SPIRE-RAL-COM-0001489

Re: JPL 10209725-Prerelease 13, Received for comment Wed 8/1/03

Figure 1 - Wiring as currently specified

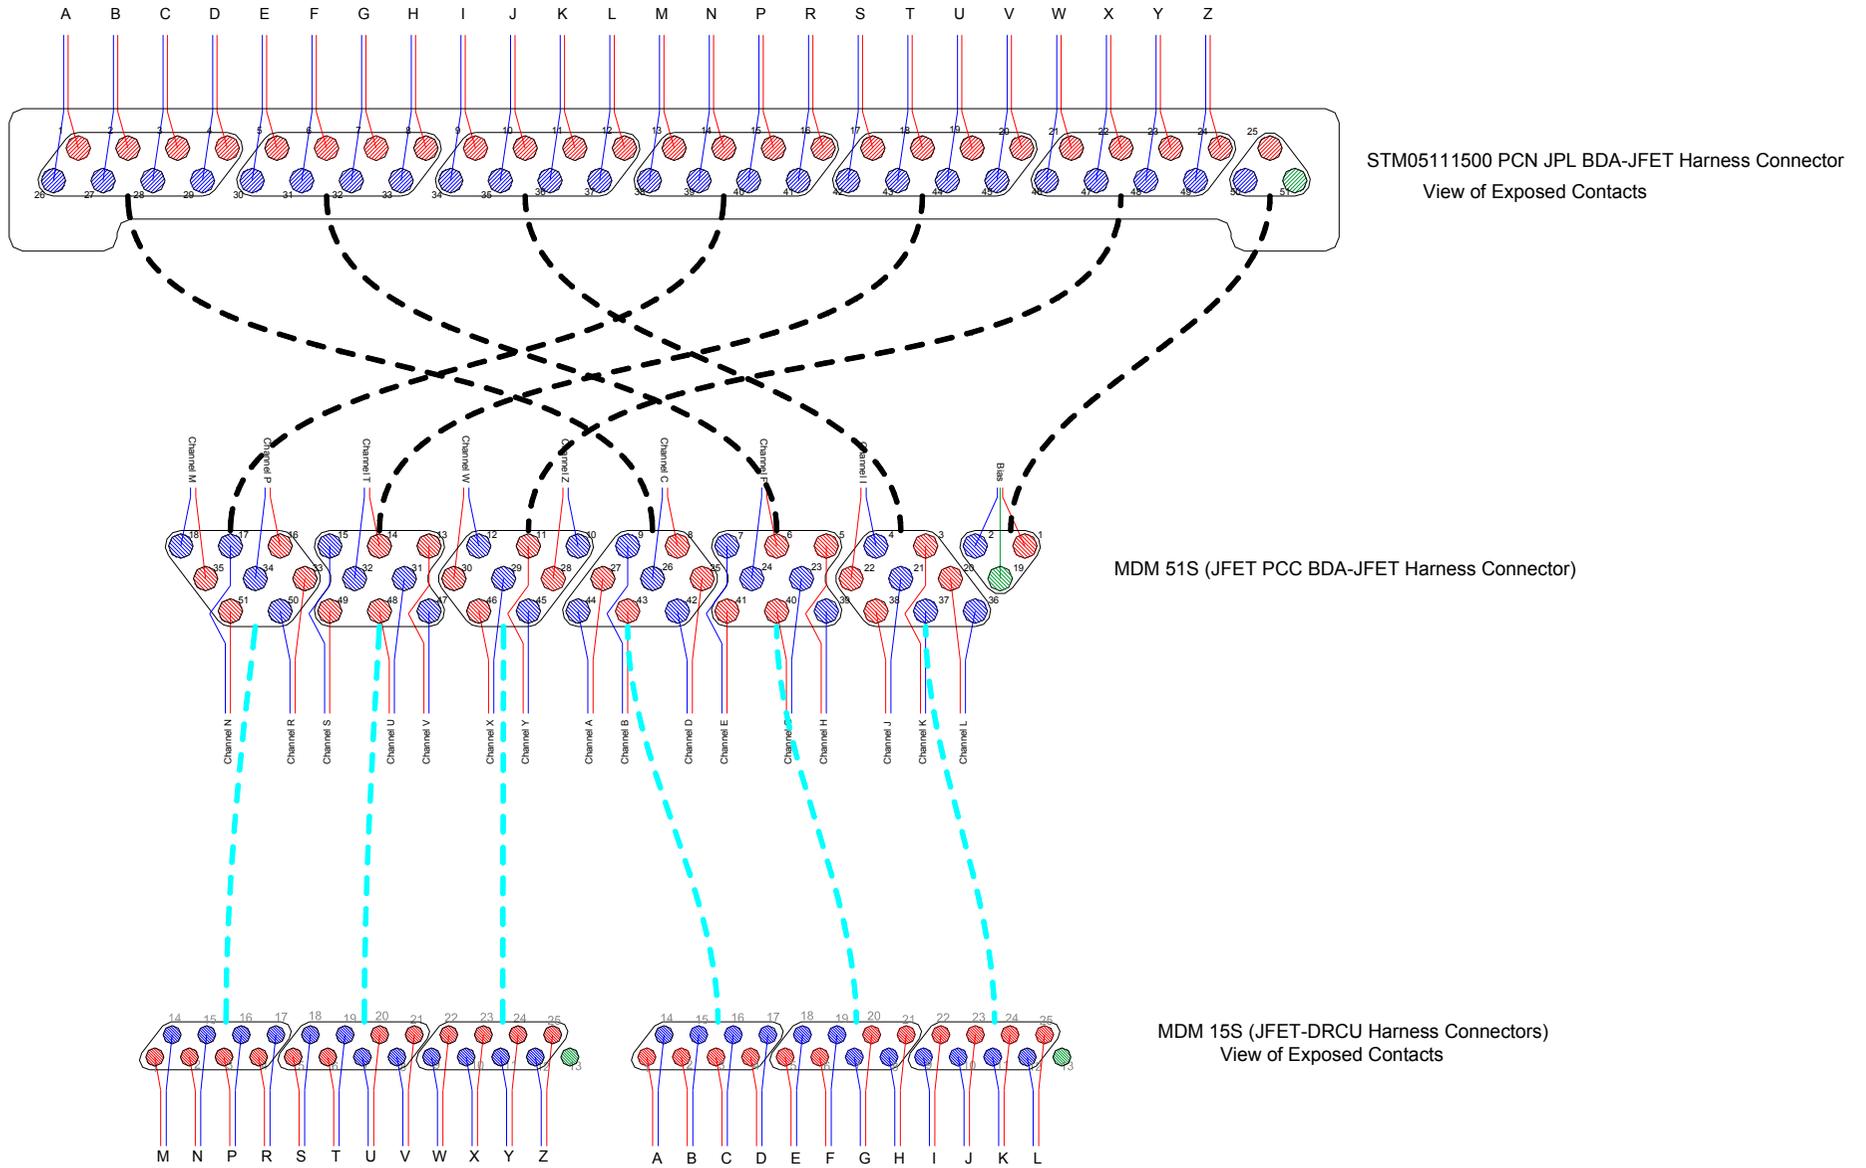
We need to have a flat layup on the harnesses between the 51-Way MDMs on the JFETs and the 51-Way Nanonics as these are implemented as flat woven harnesses.

I have drawn out in Figure 1 the pin assignments for the 51-Way Nanonics and the 51-Way MDMs as they are currently specified in JPL 10209725-Prerelease 13. The 12-ax cables have been drawn on this figure with heavy black dashed lines. Internal connections have been indicated with heavy dashed Cyan lines. The drawing reveals that it would be necessary to twist the 12-ax wires around each other¹.

¹ There are two ways that the drawing can be represented depending on the orientation of the 51-Way MDM. In either case, a flat harness layup cannot be achieved.

This can be remedied by keeping the flat woven layup in the harness and performing the twisting of the 12-axes within the potting of the 51-Way MDM. This does not seem like a good solution.

Figure 2 - Proposed modifications to JPL 10209725

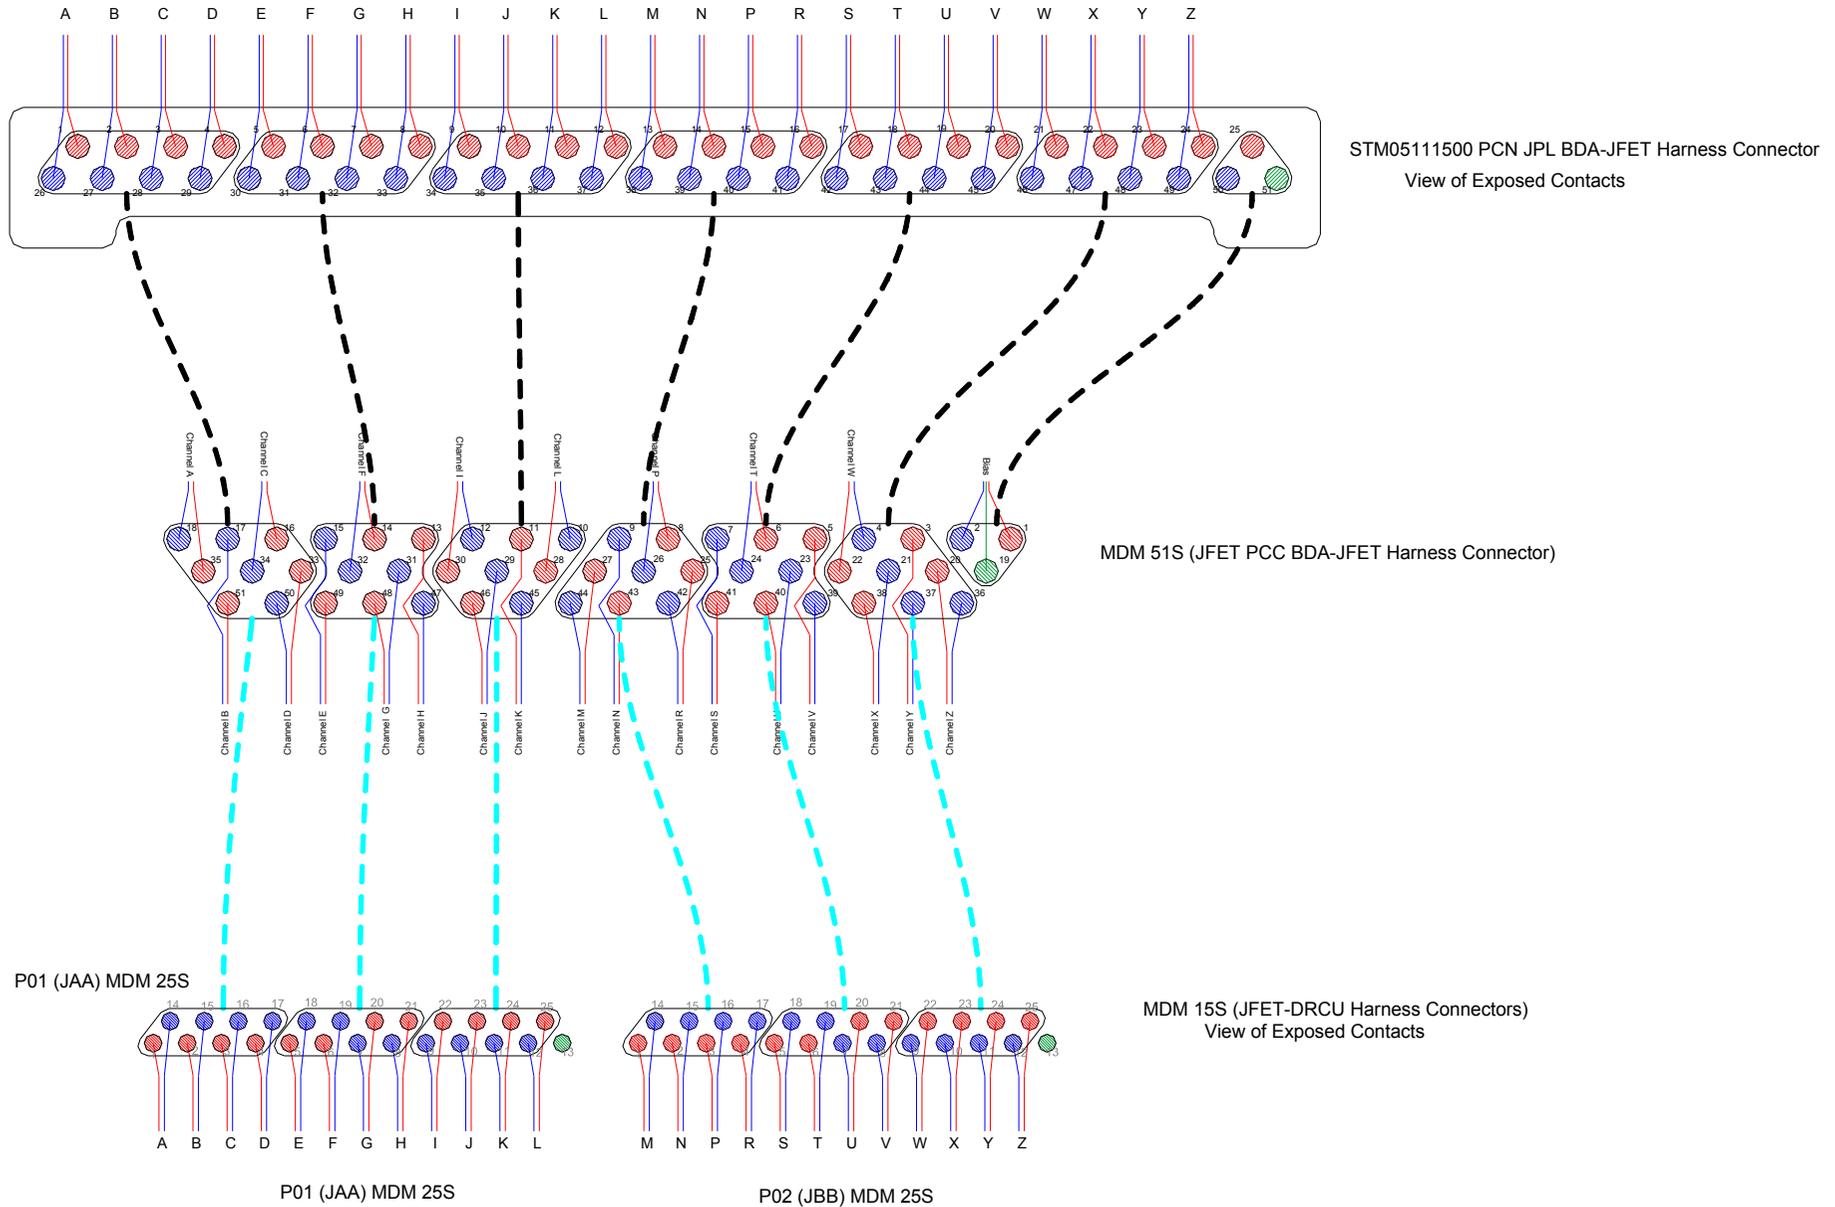
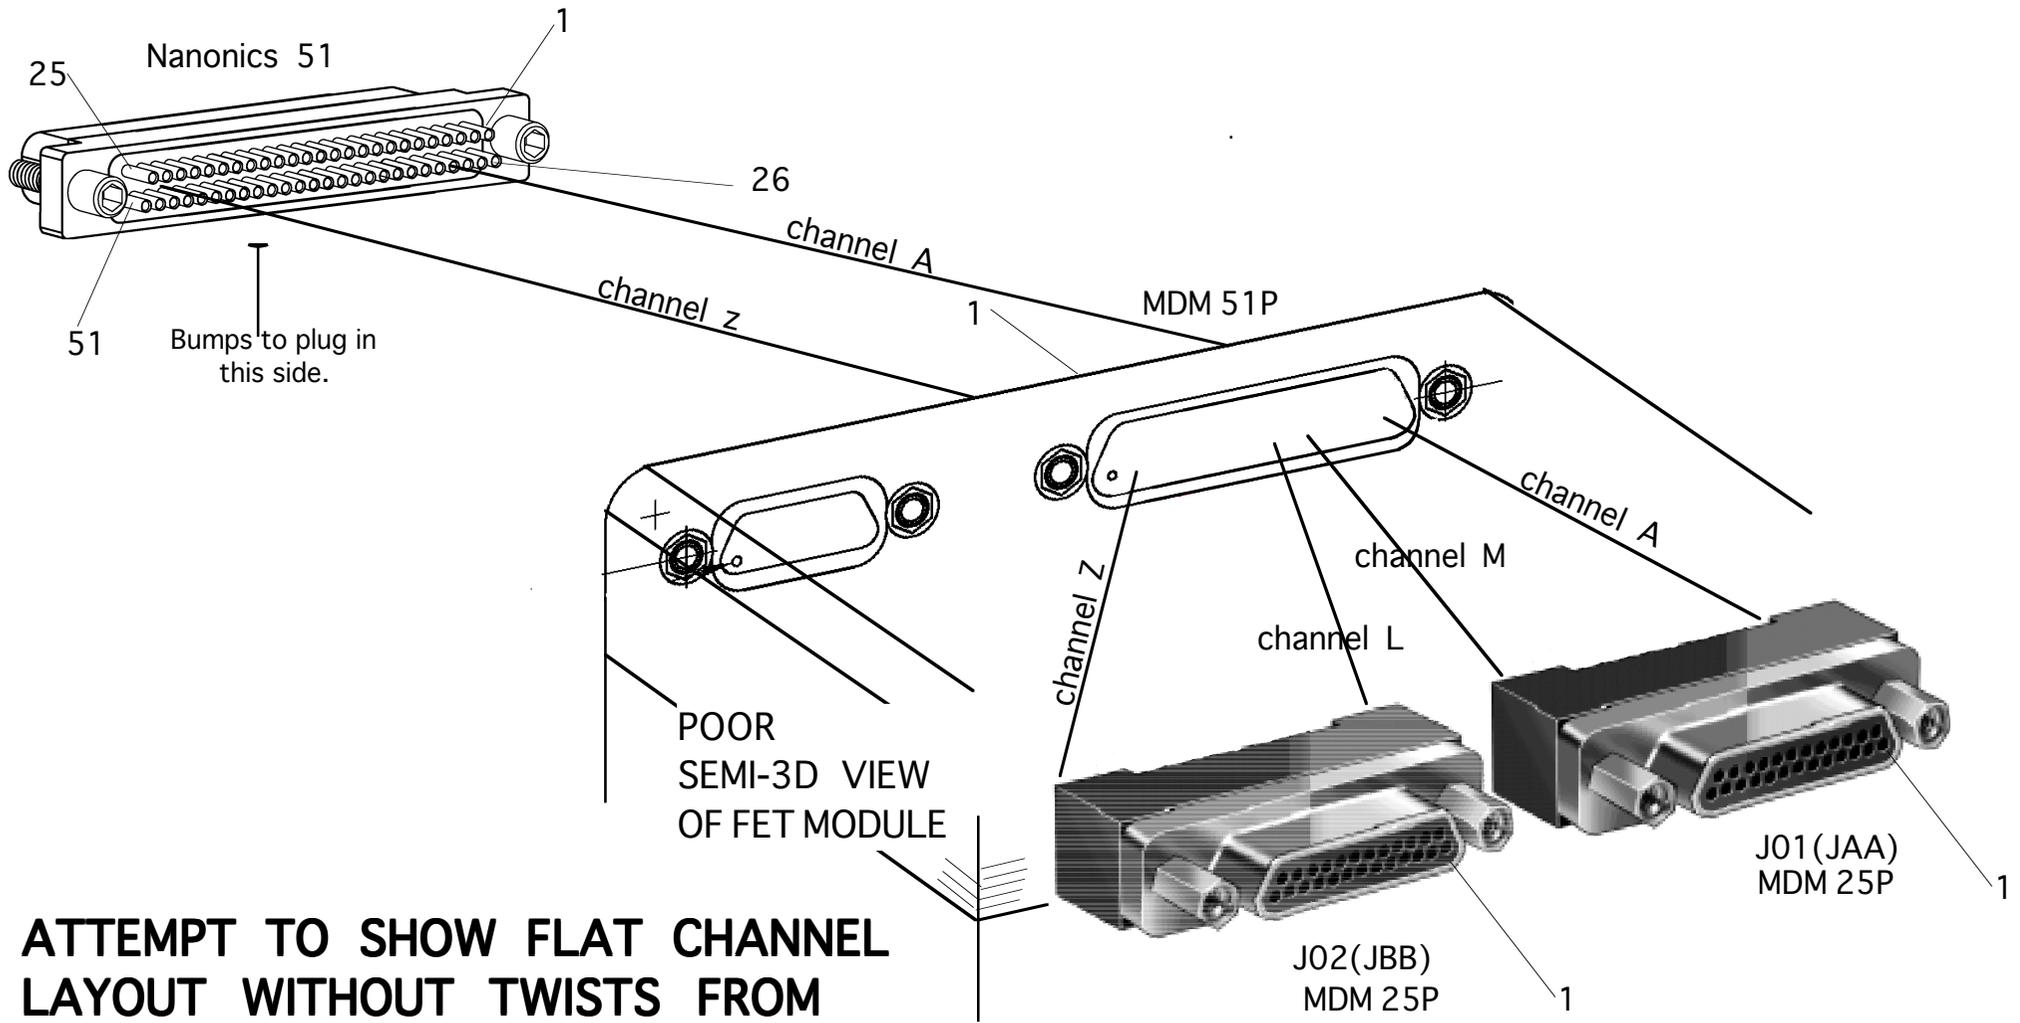
ATTEMPT TO SHOW FLAT CHANNEL LAYOUT WITHOUT TWISTS FROM NANONICS TO JFET O/PS

The other solution, is to change the Schematic as shown in Figure 2. Attached is a marked up version of 10209725 that corresponds to Figure 2. John Delderfield has also produced a 3D representation of these changes.
